VALUE ENGINEERING TEAM STUDY
AA

Value Engineering Study on the

NAPA RIVER

FLOOD CONTROL PROJECT

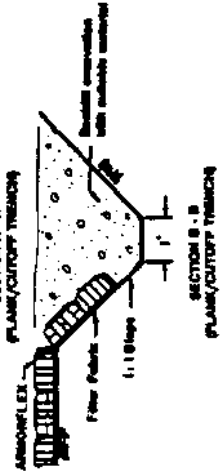
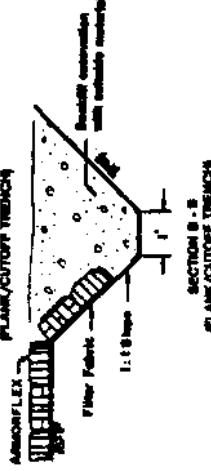
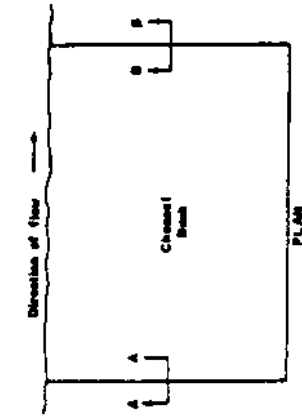
ORIGINAL DESIGN: The current design for Napa Creek includes a 12-inch thick gabion mattress to cover the invert and side slopes of the entire channel.

PROPOSED CHANGE: This proposal recommends that an interlocking cellular concrete mat system, similar to "Armorflex", be used in lieu of the gabions (see Drawing No. 1). The Armorflex mat is only one of several manufactured types of mats. Please note that the Armorflex mat can be installed on slopes of up to 1:1, without soil anchors. However, other types of mats may need to be anchored to the slope with soil anchors.

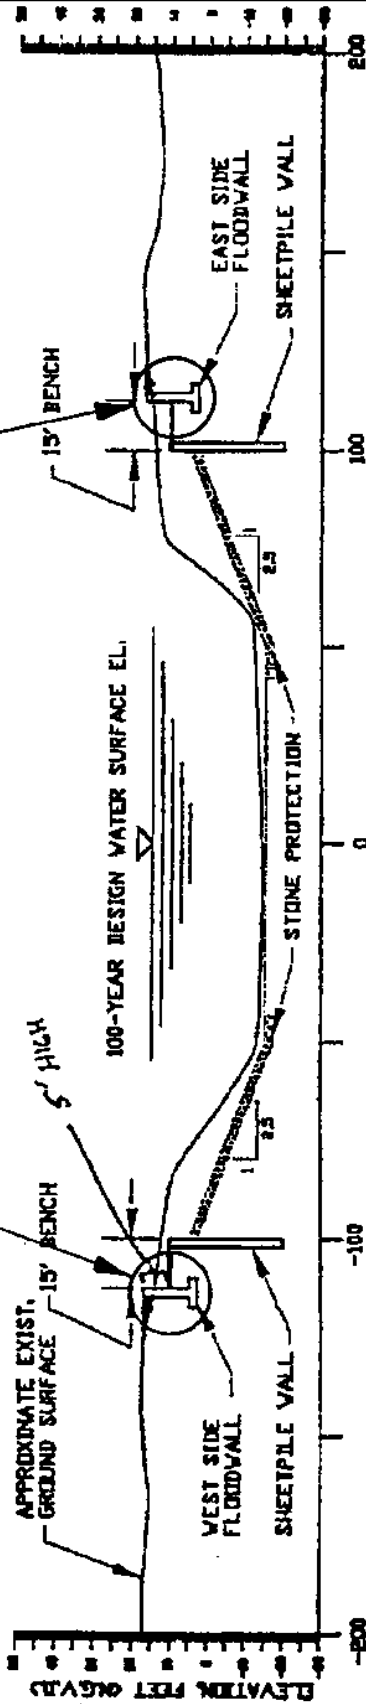
ORIGINAL DESIGN: The current design between Stations 251+00 and 256+00 on the left bank and between Stations 250+20 and 256+00 on the right bank includes a T-shaped, reinforced concrete retaining wall located 15 ft behind a steel sheet pile wall. The T-shaped wall is approximately 10 ft high, with 5 ft of exposed wall surface (see Drawing No. 1).

PROPOSED CHANGE: This proposal recommends that the concrete retaining wall be replaced with a 5-foot high reinforced earth retaining wall (see Drawing No. 2). Please note that this sketch of a reinforced earth retaining wall is a generic design based on typical soil and loading conditions. The dimension for "L" is normally equal to approximately 75% of the wall height "H".

**Revise Floodwall Design
 (see Proposed Design Sketch)**

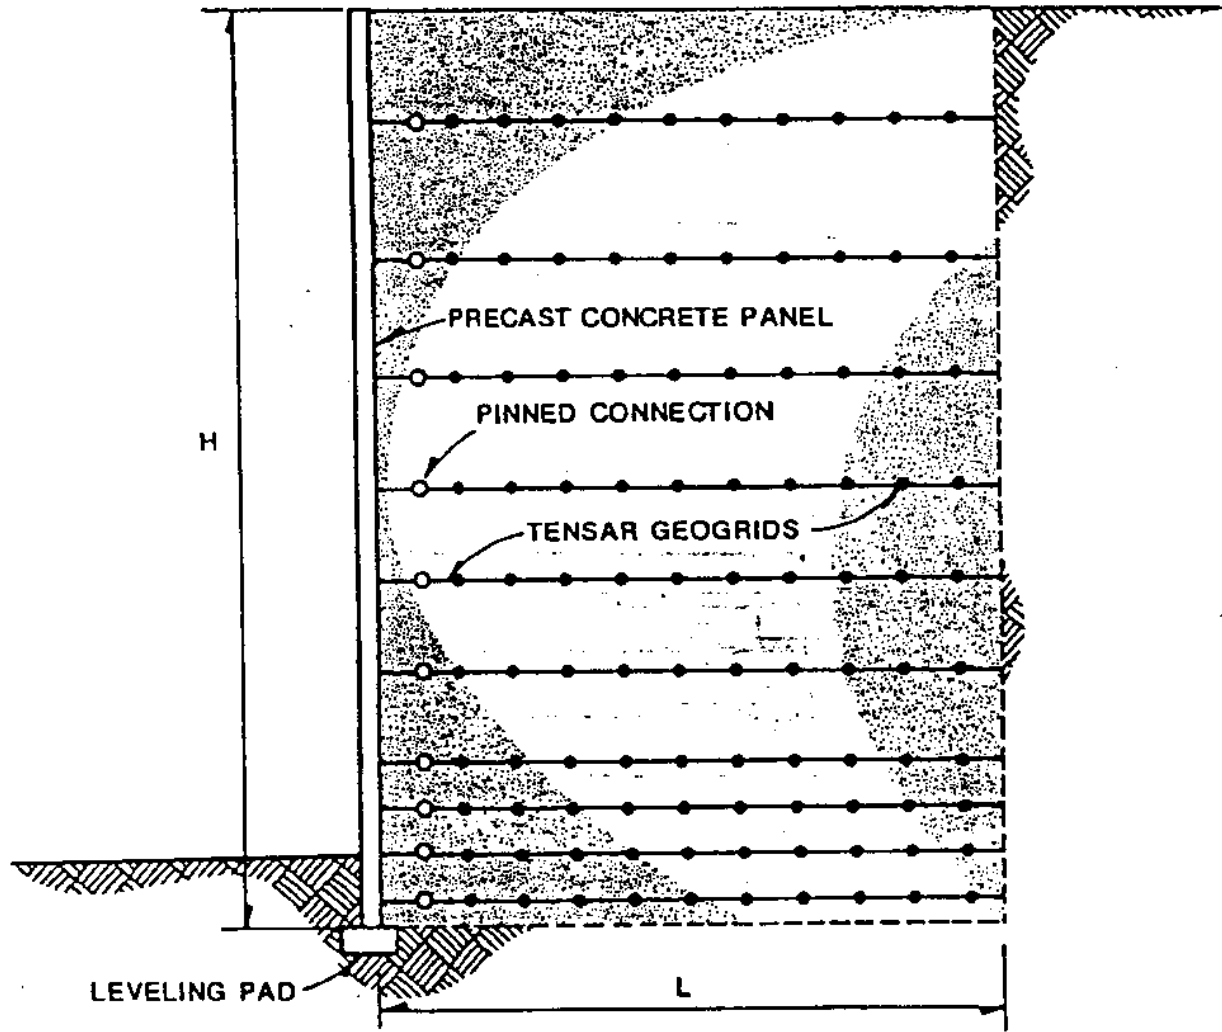
CURRENT DESIGN

PROPOSED DESIGN

Reinforced Earth Retaining Wall

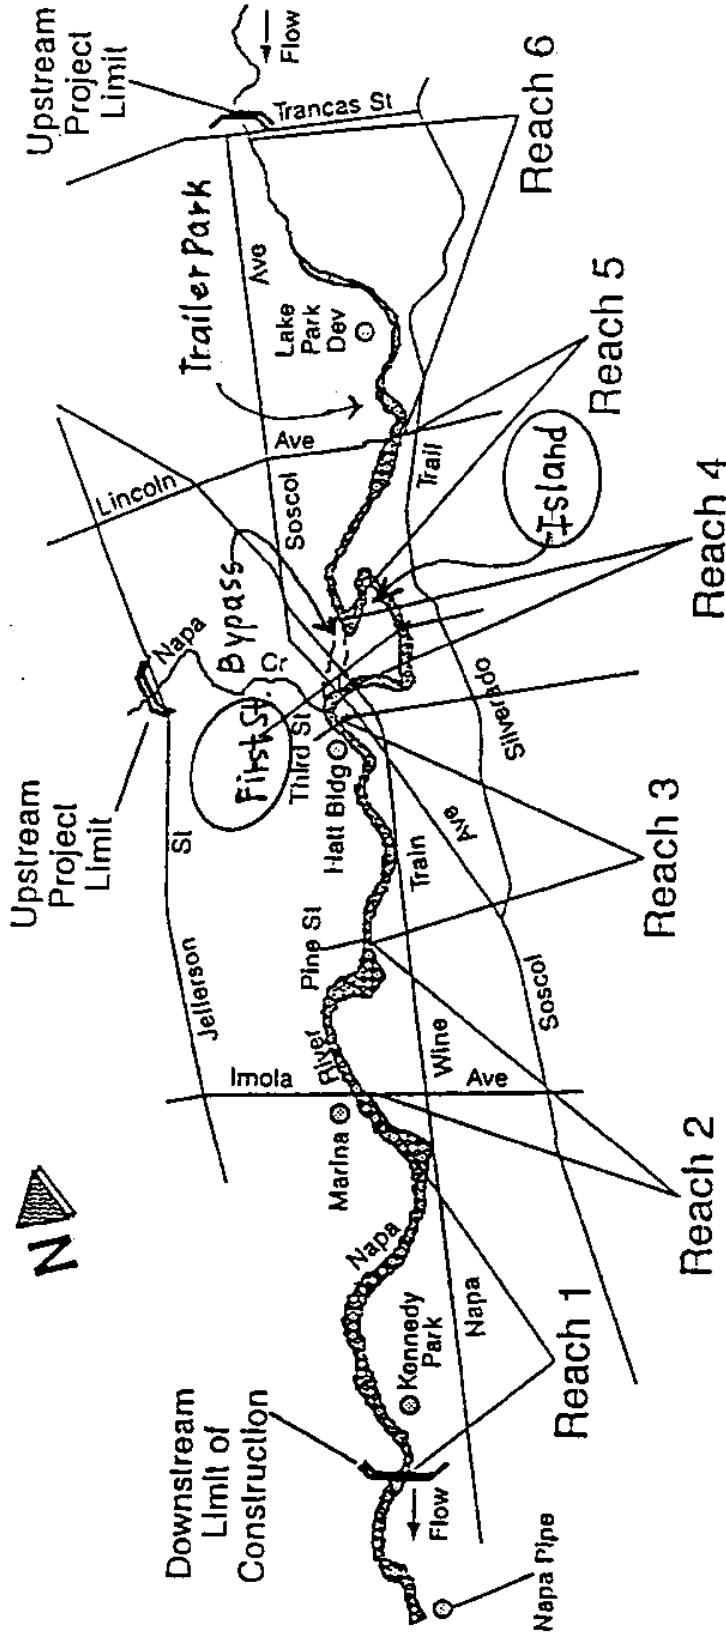
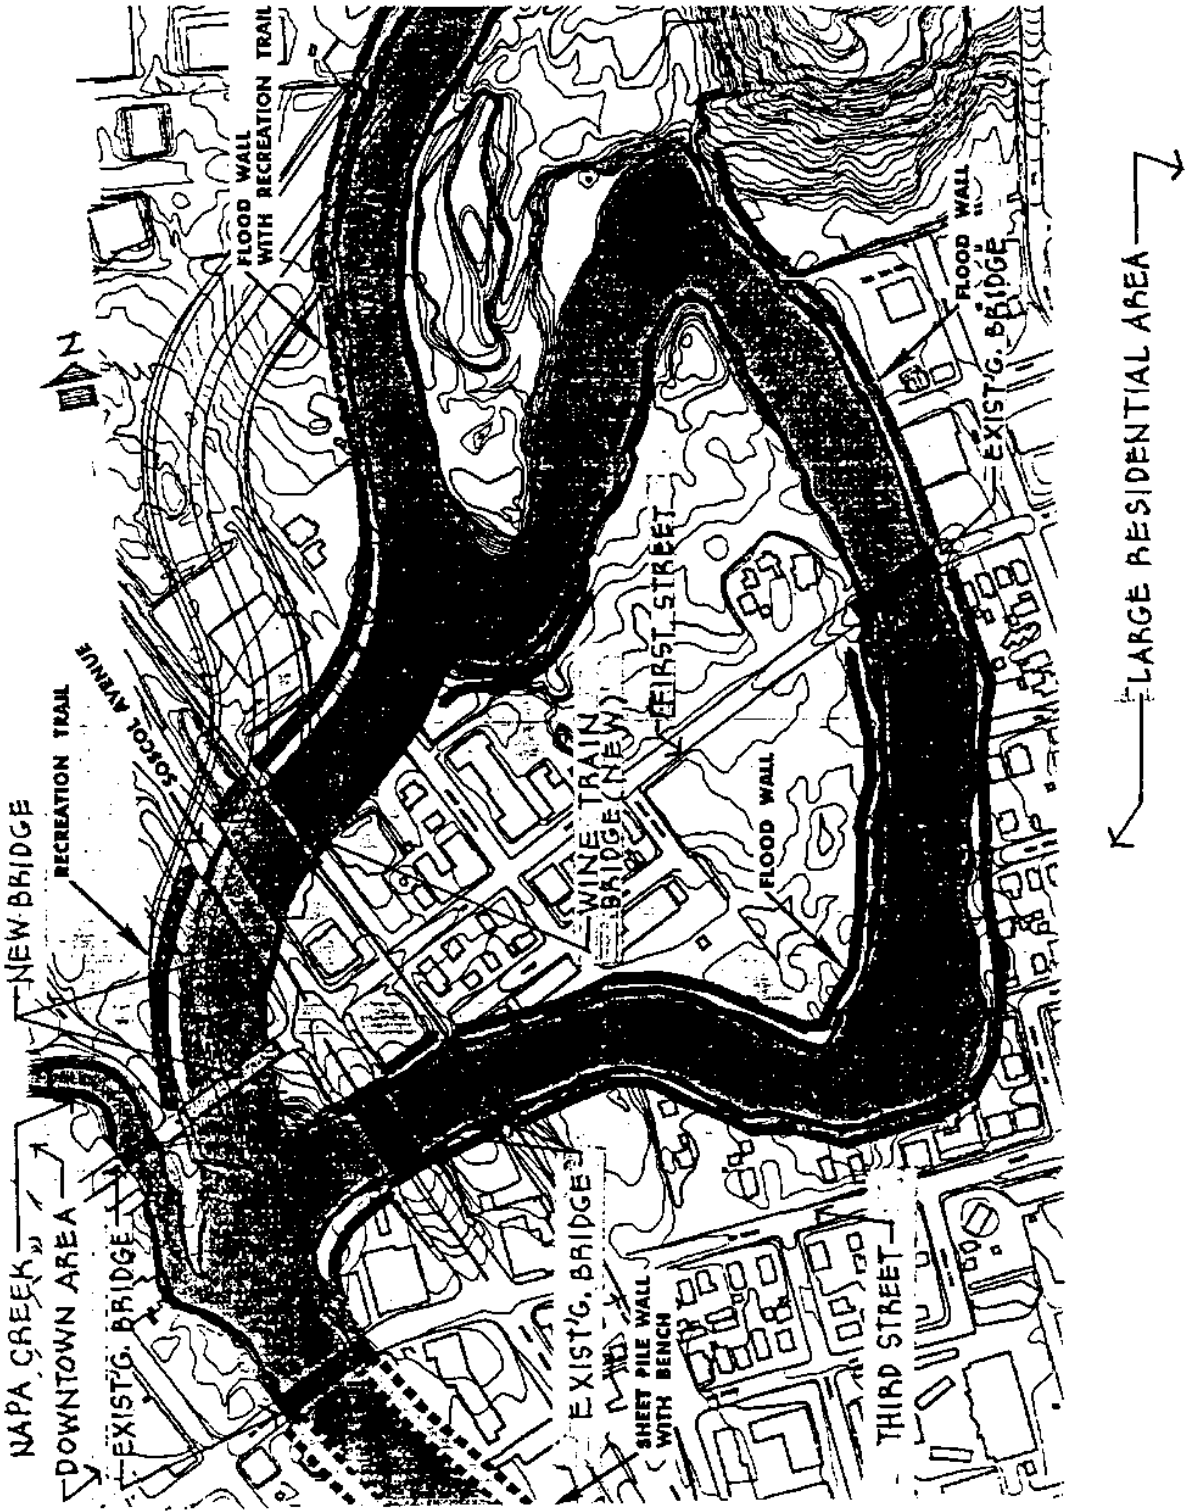
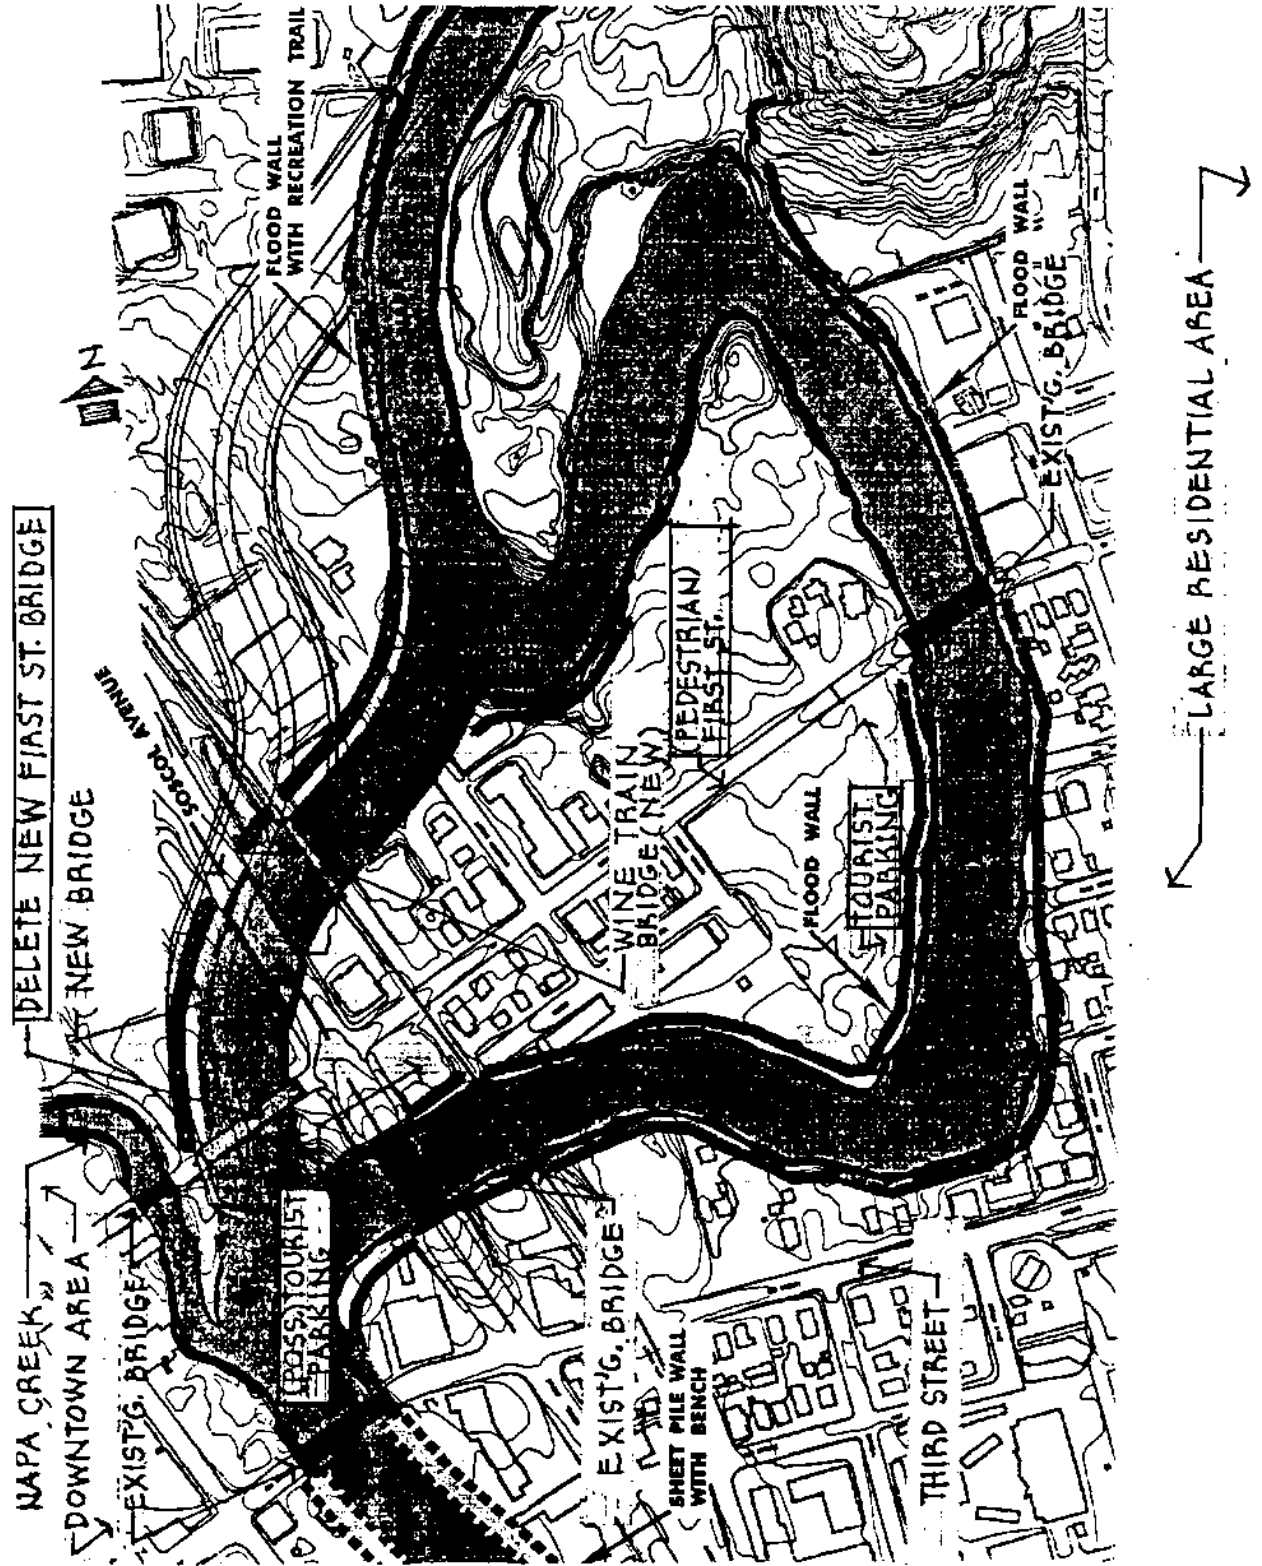
PROPOSED CHANGE: Consider that the new First Street Bridge construction be deleted from the project and First Street be closed to vehicular traffic, except for emergency vehicles and delivery/ pickup vehicles. (The latter would only be allowed at specified, non-peak hours.) Soscol Avenue would be retained, maintaining its role as a main north-south thoroughfare. This change envisions island (tourist) parking lots off Soscol to the west, and adjacent to the existing First Street Bridge approach to the east at the oxbow. A (basically) pedestrian island is created under this scenario whereby people can freely walk about the island to experience its many planned pleasures. It should be noted that it is the city's decision to make, and that the Corps does not take a position in the matter. (See Telephone Conversation Record Nos. 1, 2, 3, and 6.)

DRAWING NO. 1: DESIGN DRAWING/SKETCH

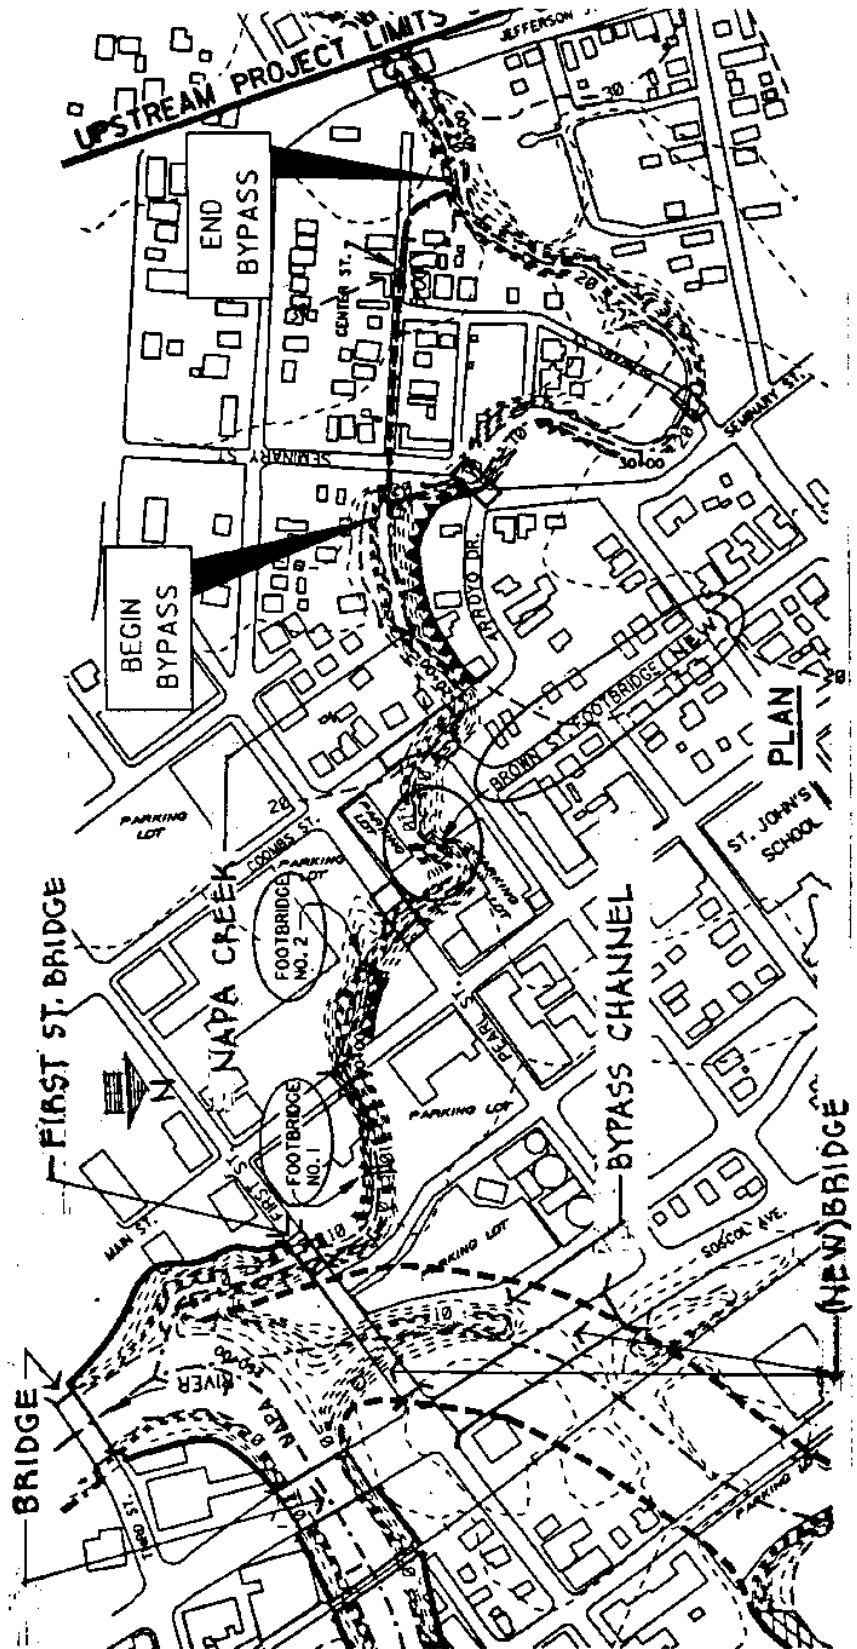
ORIGINAL DESIGN: The existing Brown Street Bridge formerly served vehicular traffic across Napa Creek. It now serves only as a footbridge for pedestrians going to the downtown area from nearby parking lots. In the project plan, it will be removed and replaced with a new footbridge since it obstructs flow. Within a distance of approximately 700' east from the proposed footbridge toward the river, there are two existing footbridges, the Main Street Bridge and the Pearl Street Bridge (see Drawing and Telephone Conversation Record No. 5).

PROPOSED CHANGE: Recommend the replacement Brown Street Footbridge be eliminated from the project.

DRAWING NO. 2: DESIGN DRAWING/SKETCH

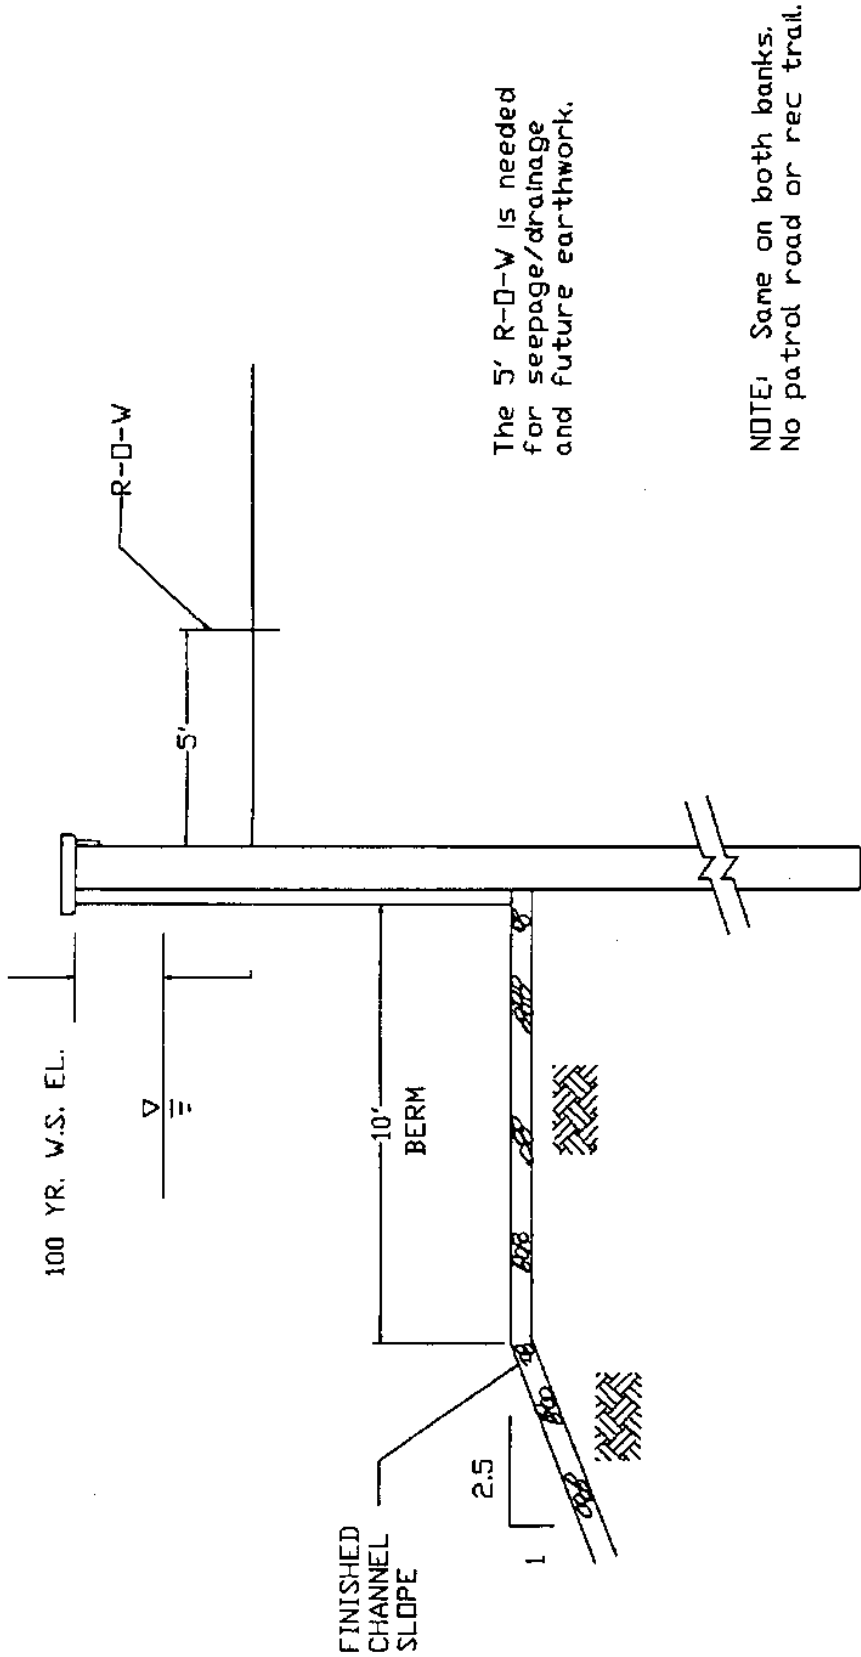
ORIGINAL DESIGN: The current design provides 174,700 SF of PZ-40 and 32,400 SF of PZ-27 steel sheet pile for retaining walls along approximately 3,400 LF of the Napa River. Exposed walls are two heights - 8 1/2 and 14 feet. Depths are estimated to vary to 40 feet. The typical sections feature a simple I-Wall channel wall from Pine to Fifth Streets (Station 220+00 to Station 251+00), and a shorter wall as part of the bench wall system at Fifth to Third Streets (Station 251+00 to Station 256+00).

PROPOSED DESIGN: It is recommended the option be provided to allow both hot and cold formed steel sheet pile if design conditions are met by both products. Cold formed CZ sections provide two options for the PZ-27. CZ 128 has a section modulus of 35.34 cu. in./LF with a weight advantage of 26.2 (vs. 27 #/SF for PZ-27). CZ 114 has a section modulus of 31.62 with a weight advantage of 23.4 vs. 27 #/SF (saves 3.6 #/SF). It was recommended the designers revisit the requirement for the wall sections currently shown as PZ-40. If the walls can be designed to PZ-35, based on complete project soils data when available, a cold formed section can be used. CZ 148 has a section modulus of 40.92, exceeding the PZ-35 section, and a weight advantage of 30.3 vs. 35 #/SF. Where both materials are specified based on performance to project conditions, competition in bidding will be improved. CASTEEL has over 10 years in production in Canada (has been in the U.S. 3 years), and has furnished products to Corps project in several areas in the U.S. See Appendix G for supporting data. Prices for materials delivered on site were given as follows:
